**ADDENDA
00 91 13 E-03**

Project:
COMMUNITY CARE CITY OF KAWARTHA LAKES CCCKL COMMUNITY HEALTH CENTRE

Drawing Title:
GROUND FLOOR PLAN - POWER AND SYSTEMS

Scale: 1 : 75
Date: 2021/07/05
Job No.: 2171348
Drawn by: JP
Drawing No.: **E300**

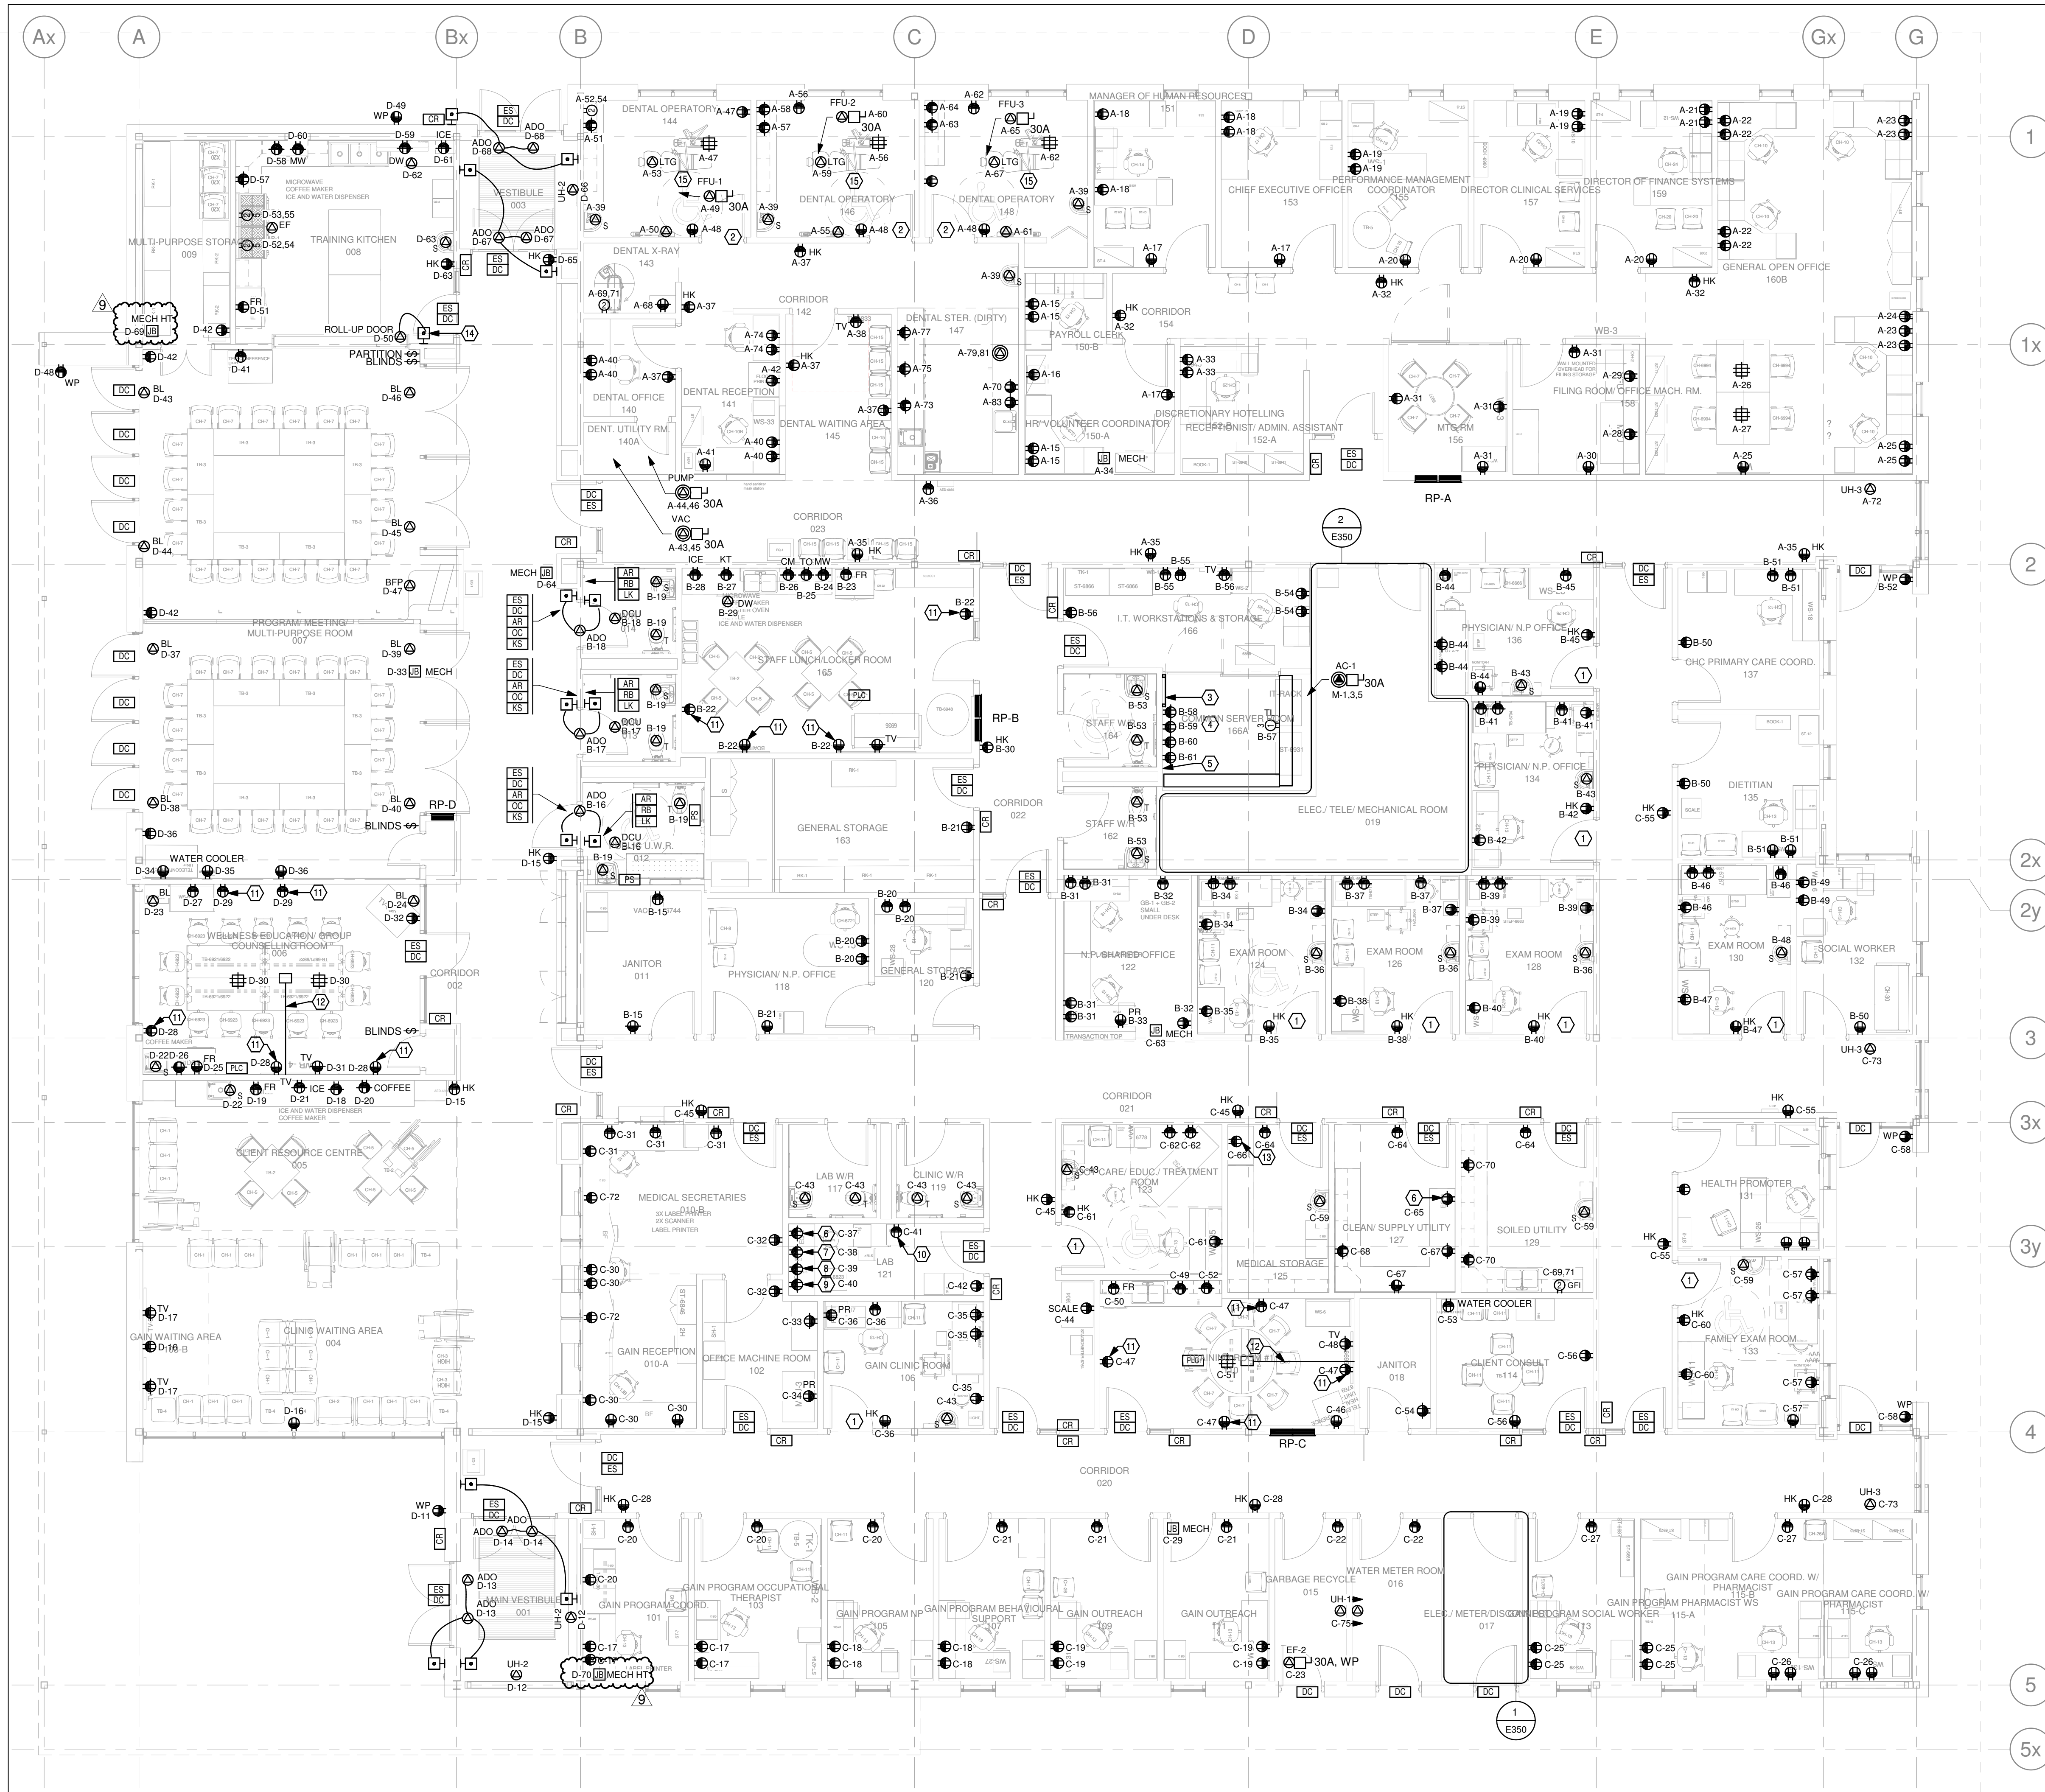
1.1 Refer to Drawing E300 – Ground Floor Plan – Power & Systems (issued within)

- .1 Added two 120V GFI circuits to be used for heat tracing. Power is by division 26, heat tracing cables, controller etc are by division 20.
